**Red Dog Mine
Closure and Reclamation Plan**

**RED DOG CREEK REDIVERSION
DESIGN CRITERIA AND PLAN**

ADDENDUM

Subject: **Asbuilt of Red Dog Creek Rediversion**

Red Dog Mine Red Dog Creek ReDiversion Section S4 Figure 6		
Revision: 1	Scale: As Shown	MWO or Job #: C3781

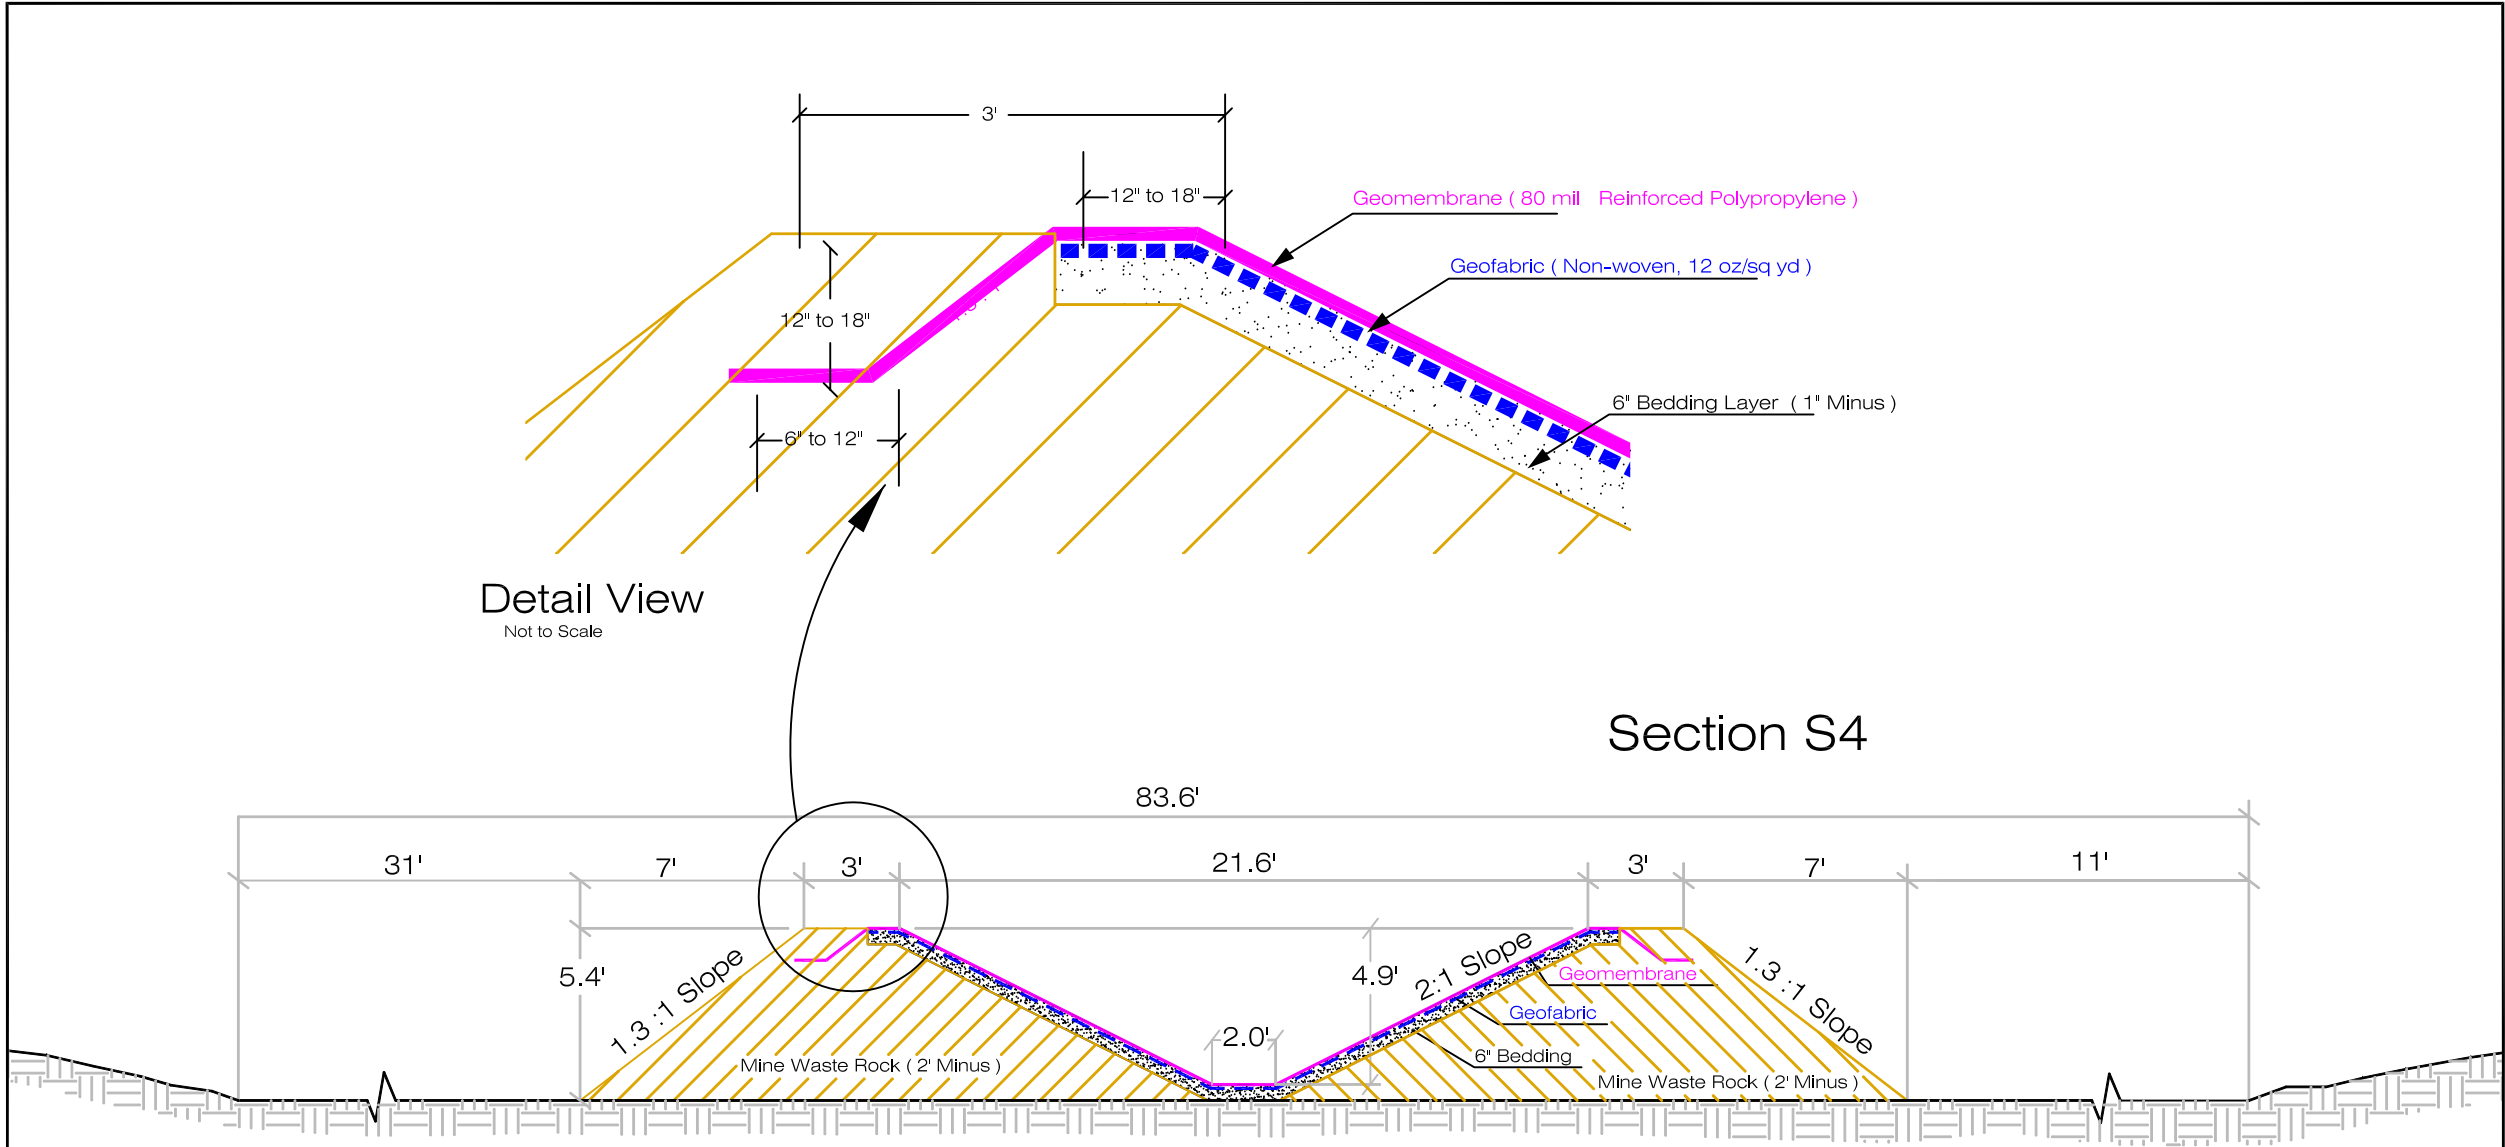
The 6 ft diameter culvert road crossing in Connie Creek (S4) was not installed. Instead a bridge was installed across Red Dog Creek (S1) directly upstream of the lateral.

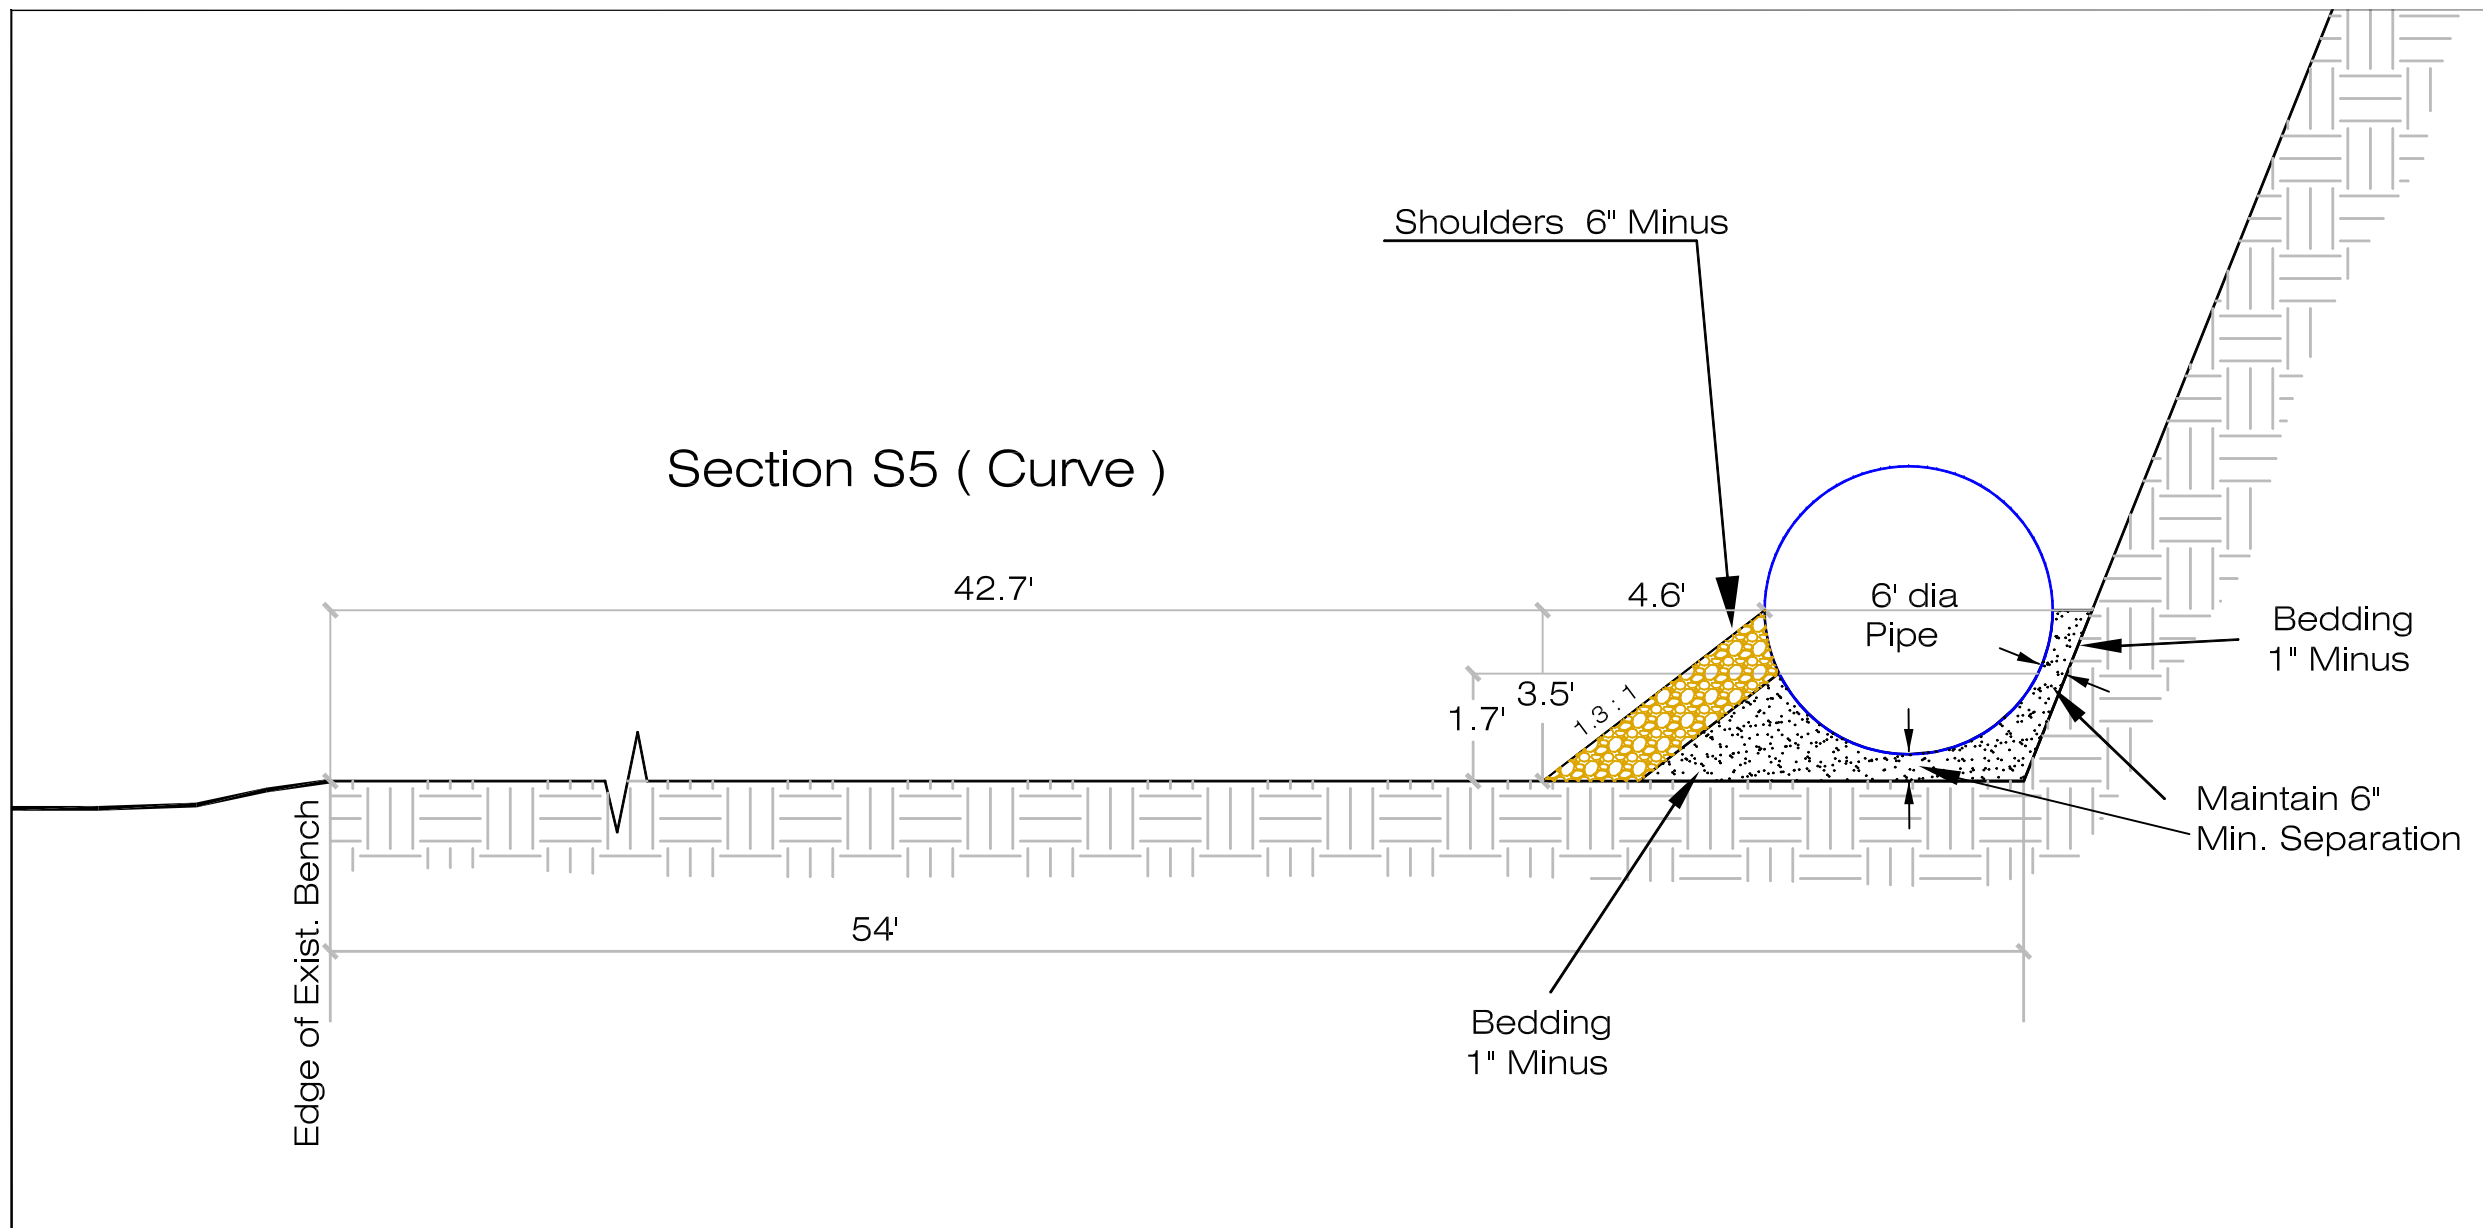
The flexible liner open channel dimensions were as designed. The culvert installed in Shelly Creek (S5) was 6 ft diameter instead of 5.5 ft diameter.

Red Dog Mine Red Dog Creek ReDiversion Gabion Basket Detail Figure 9 Section S4		
Revision: 2	Scale: 1" = 6'	MWO or Job #: C3781

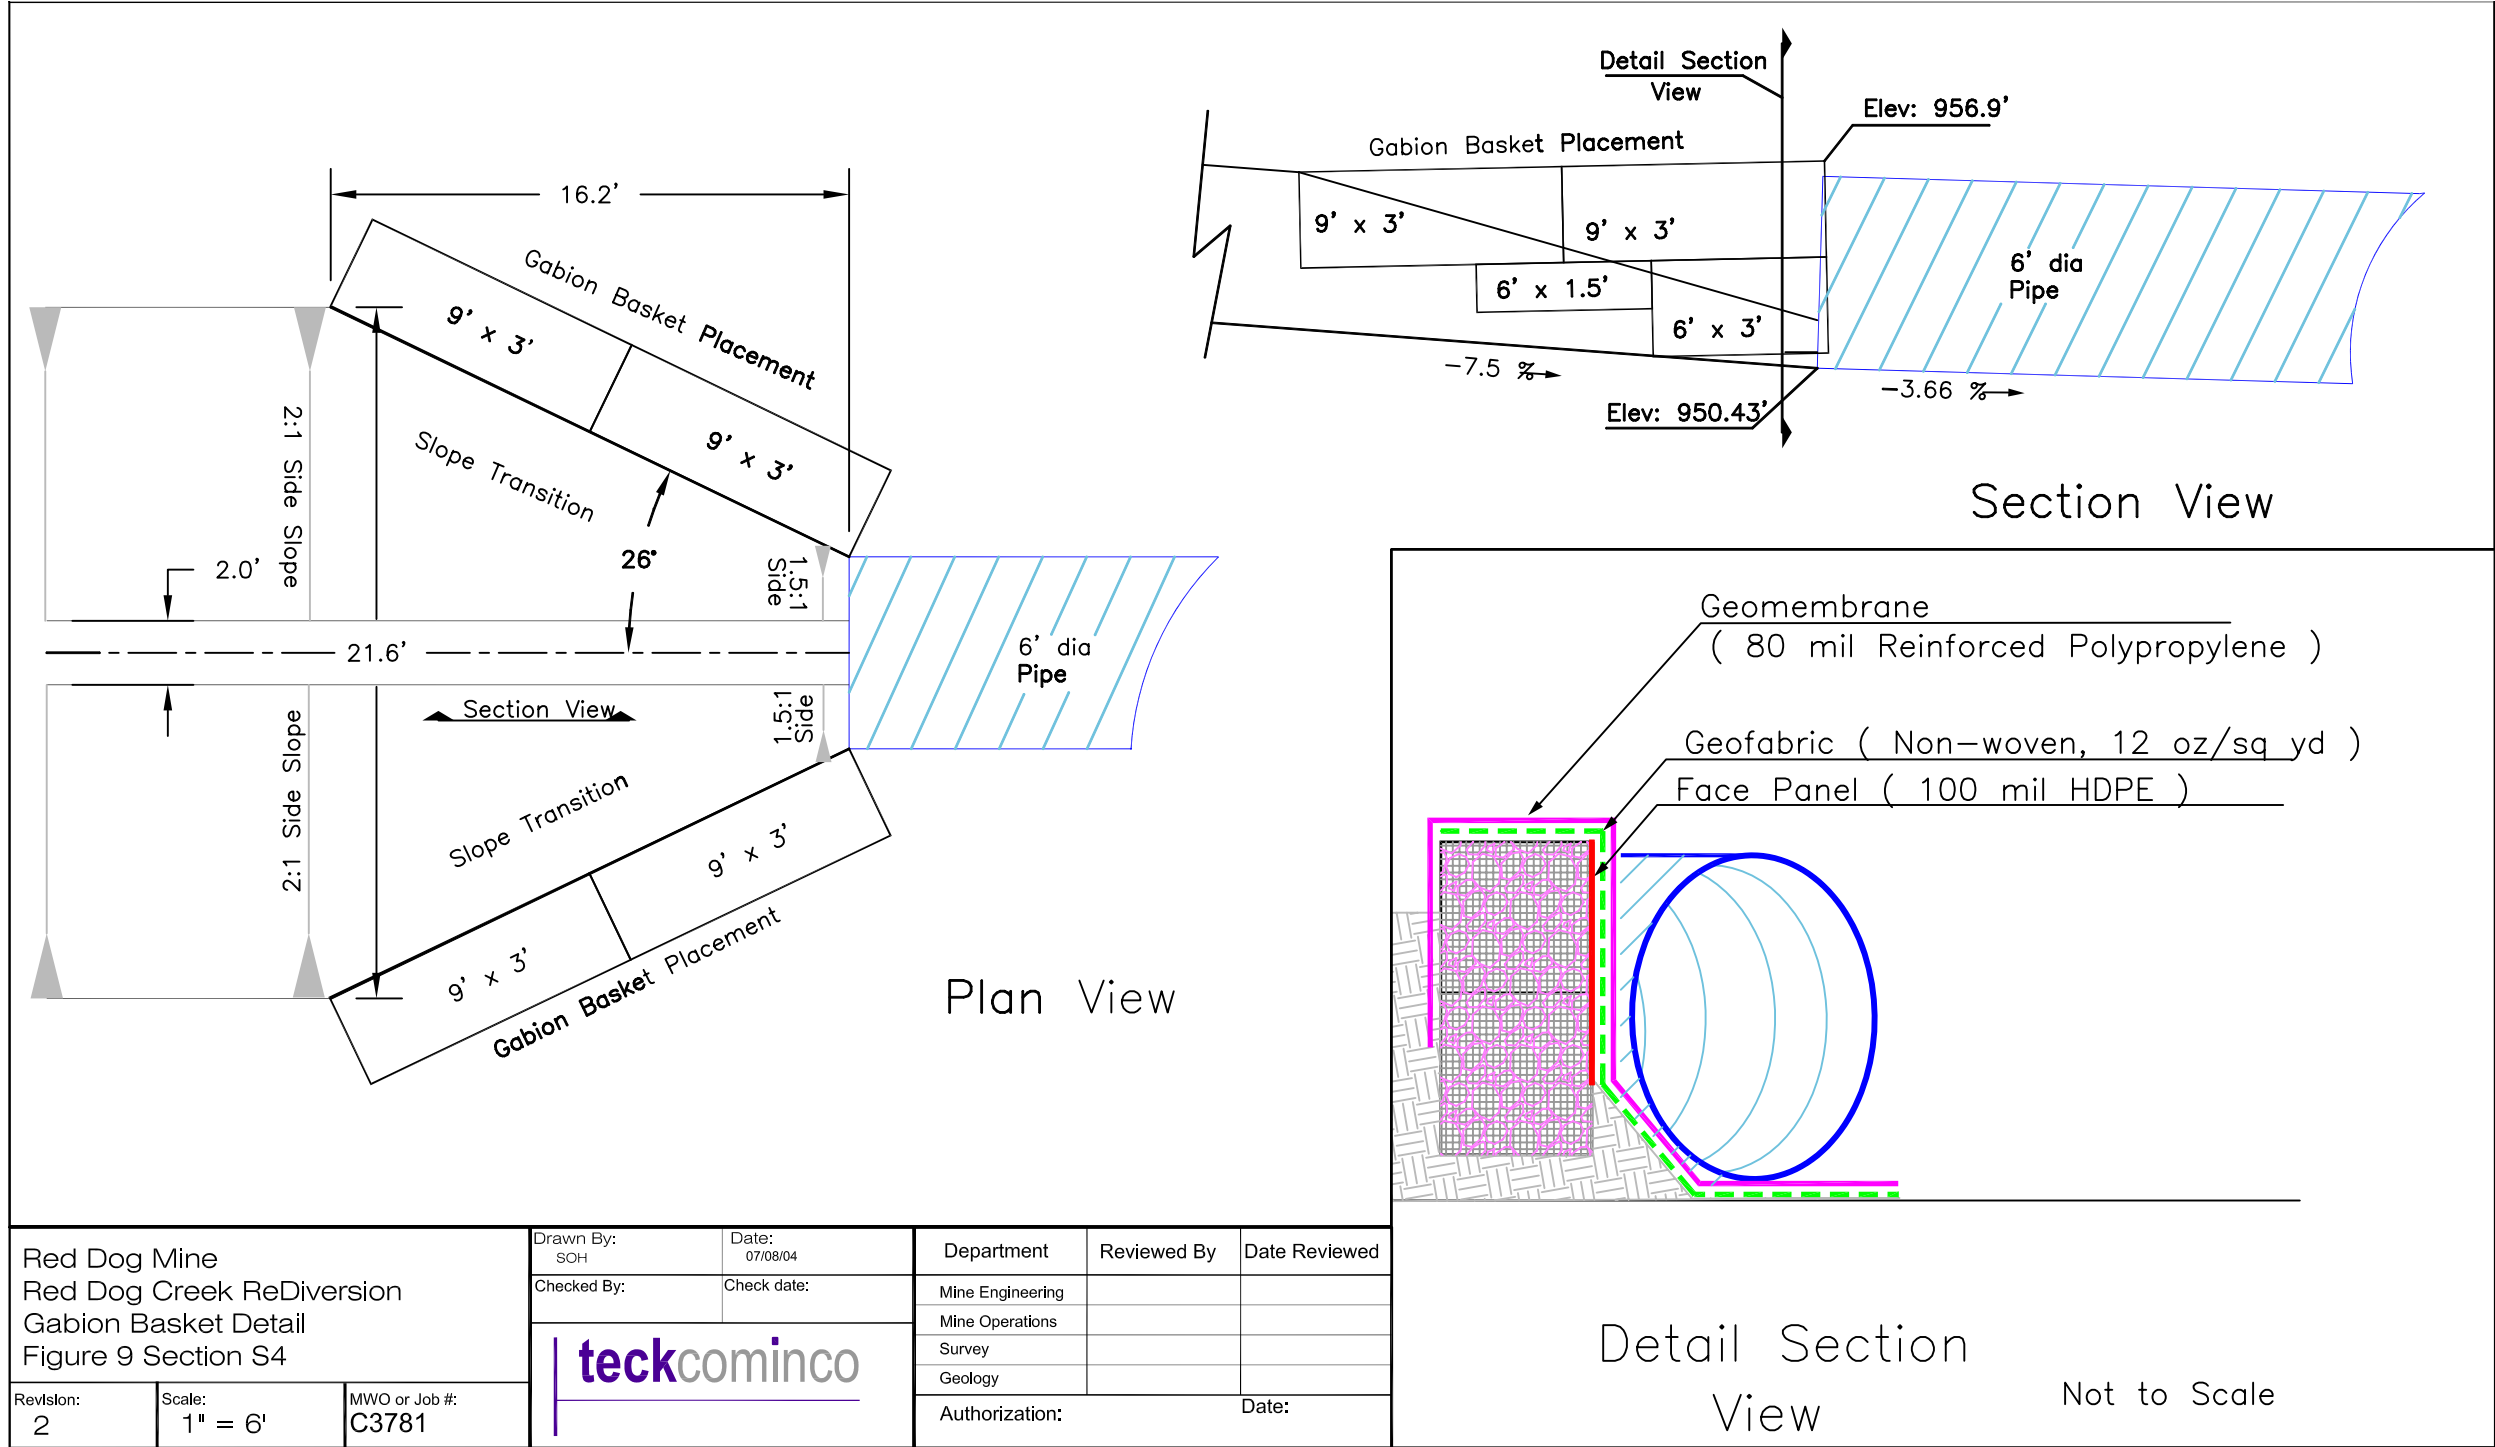
The seepage prevention liner on the upstream face of the drop-box in Connie Creek (S4) was not installed at a shallow angle from the lip of the drop-box as designed. Instead the upstream face of the box and the adjacent earth dam walls were excavated to the depth of the drop-box and the liner run from the lip of the drop box, as well as out to the left and right of the dropbox, down to the bottom of the excavation. The excavation was then backfilled to the original grade of the stream.
